ENGINEERING CHANGE NOTICE NO.

05110

DWG NO. 647.7700

DWG TITLE: STRUT ASSY

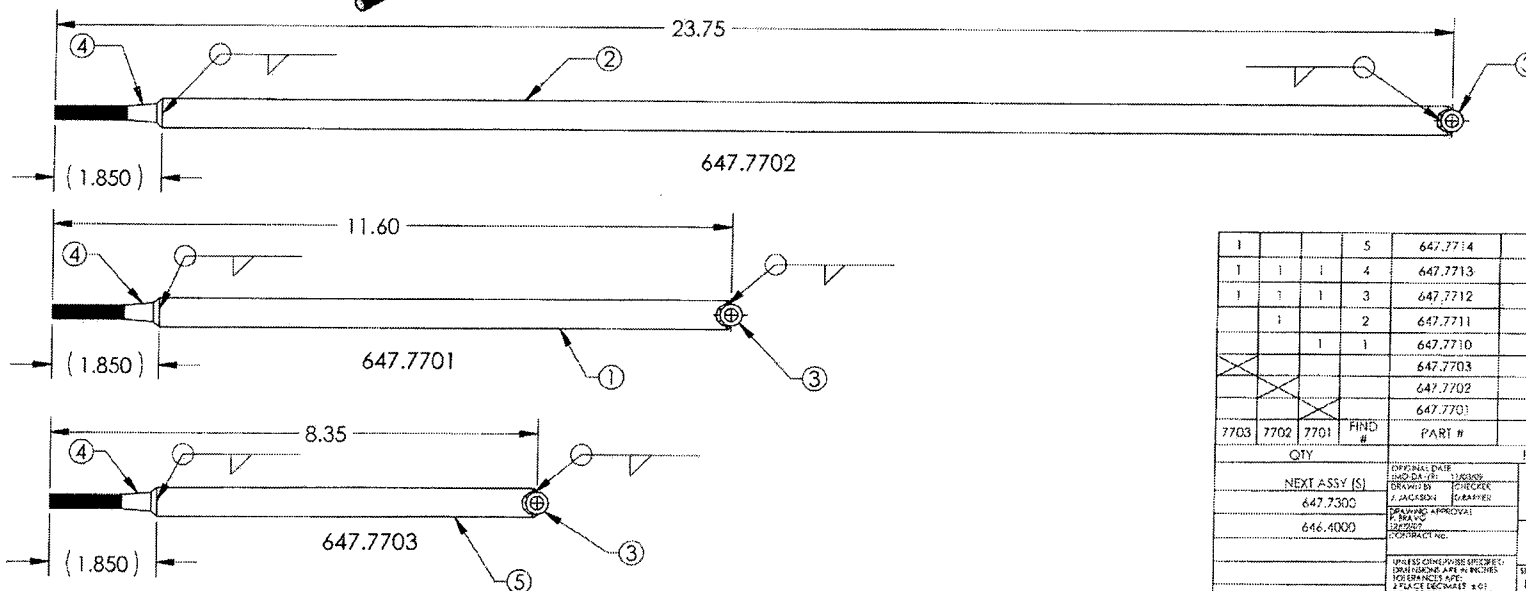
REASON: REVISED FINISH CALLOUT AS PER ECR 15-209

SHEET 1, NOTES IS:

- 1 MATERIAL: 4130 STEEL PER AMS-T-6736, .50" OD, .083" WALL THK.
- 2 MATERIAL: 4130 STEEL PER AMS-T-6736, .375" OD, .075" WALL THK.
- 3 MATERIAL: 4130 STEEL PER AMS-T-6736, .324" OD.
- 4 FINISH: PRIME IAW MIL-P-2337J TYPE I CLASS N; 1-2 MIL MAX
5. DEBURR AND BREAK ALL SHARP EDGES
6. IDENTIFY IAW MPP-120.
- 7 WELD IAW MIL-STD-2219. TIG WELD WITH FILLER ROD
- 8 FINISH: CAD PLATE IAW QQ-P-416F CLASS I TYPE II
- 9 MASK THREAD PRIOR TO FINISH

ACTION: UPDATE MO & WO
